UNITED STATES  
NUCLEAR REGULATORY COMMISSION  
WASHINGTON, D. C. 20555

Generic Task No. A-7

SUBJECT: SUMMARY OF MEETING HELD ON FEBRUARY 7, 1980, WITH  
THE MARK I OWNERS GROUP

On February 7, 1980, the staff met with representatives of the Mark I Owners Group in Bethesda, Maryland, to discuss revisions to the NRC Acceptance Criteria and outstanding issues relative to the Mark I Containment Long Term Program. The attendees of the meeting are listed in Enclosure 1.

SRV TORUS SHELL PRESSURE ATTENUATION

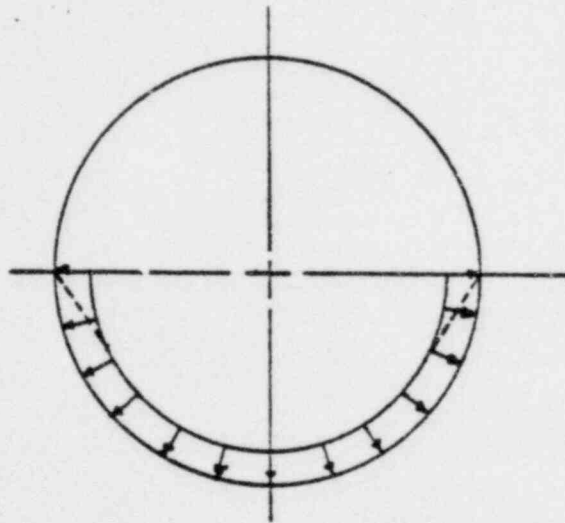
PRESSURE PREDICTIONS AT LARGE DISTANCES FROM  
THE QUENCHER RESULT IN:

(SEE EQUATION 2-23 NEDE-21878-P)

RESOLUTION: ATTENUATE TO ZERO AT WATER SURFACE

## RESULTS

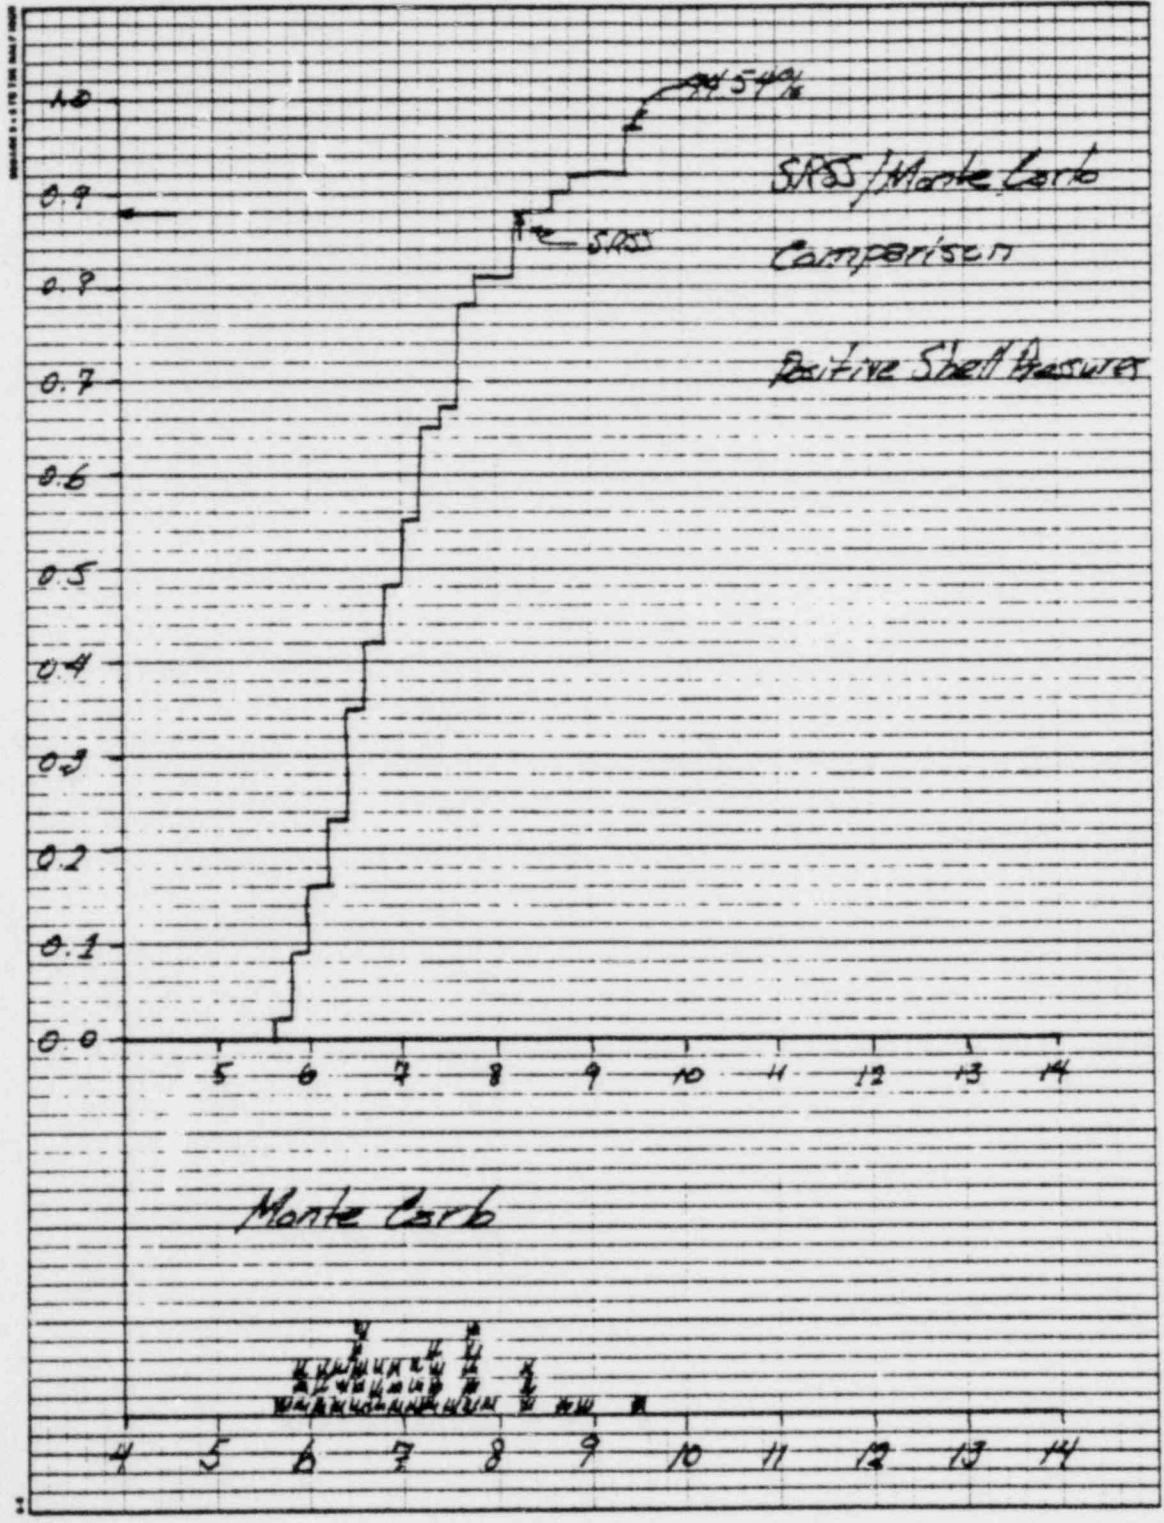
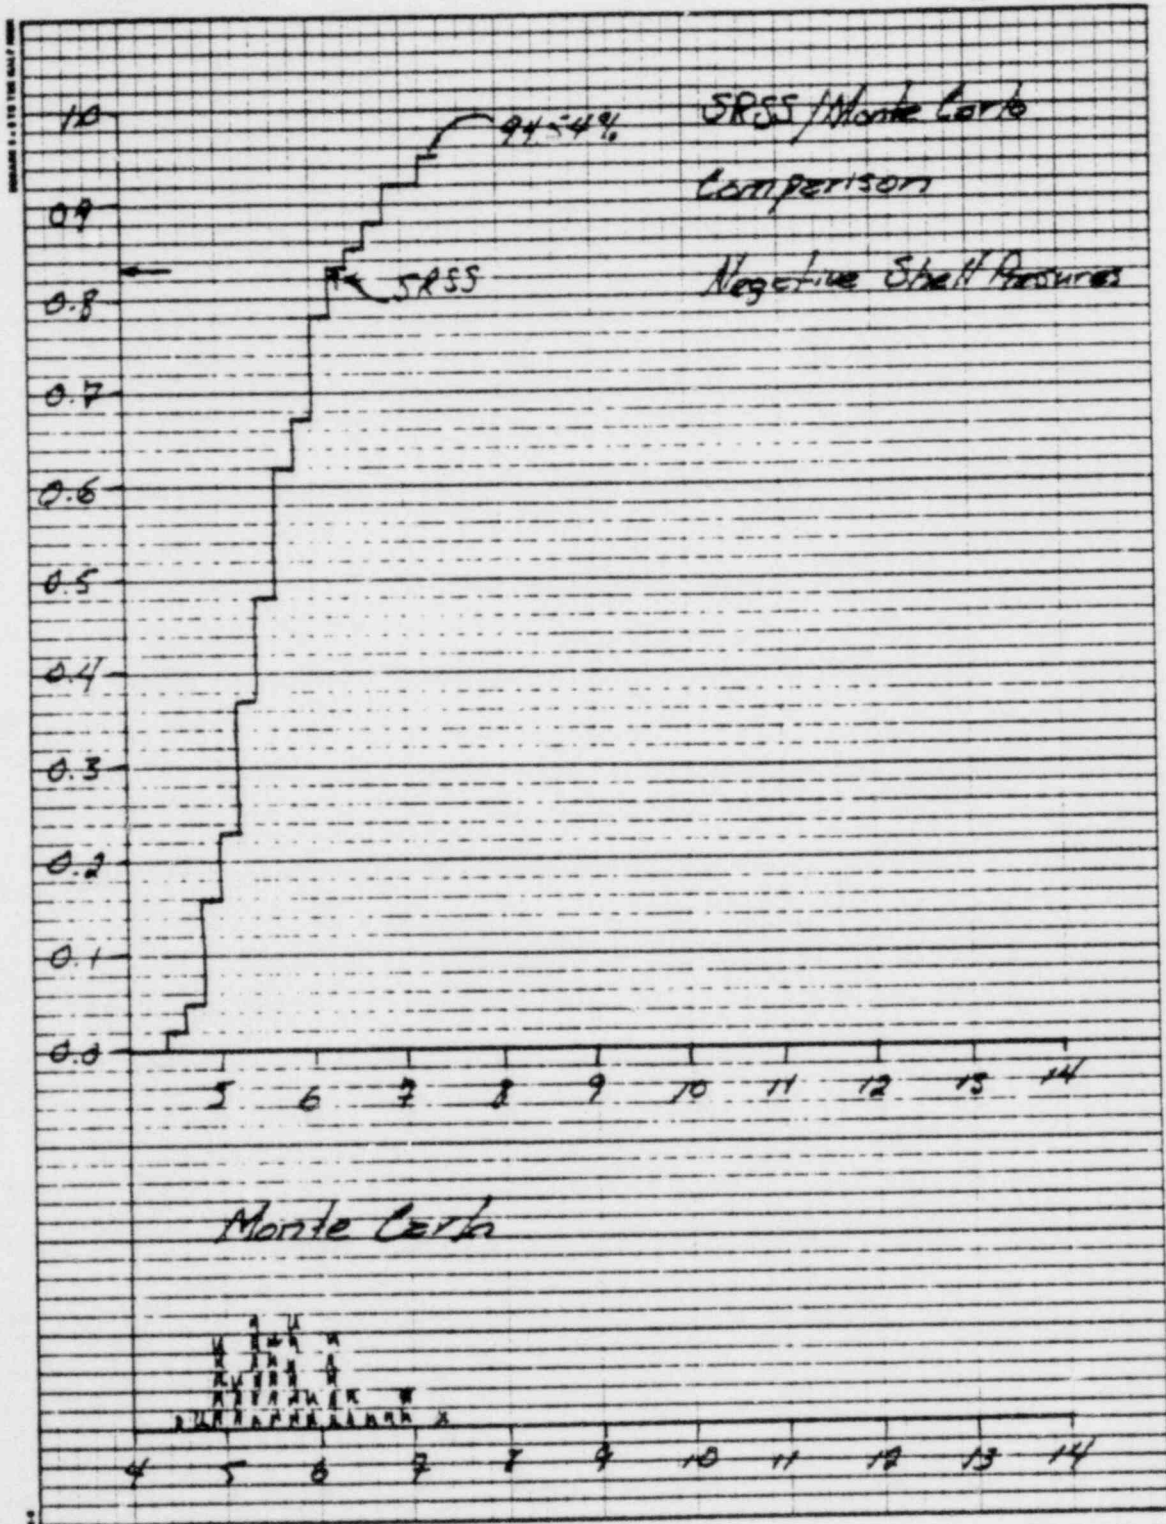
- POSITIVE SHELL PRESSURES

SRSS BOUNDS 88% OF MONTE CARLO POPULATION

- NEGATIVE SHELL PRESSURES

SRSS BOUNDS 83% OF MONTE CARLO POPULATION
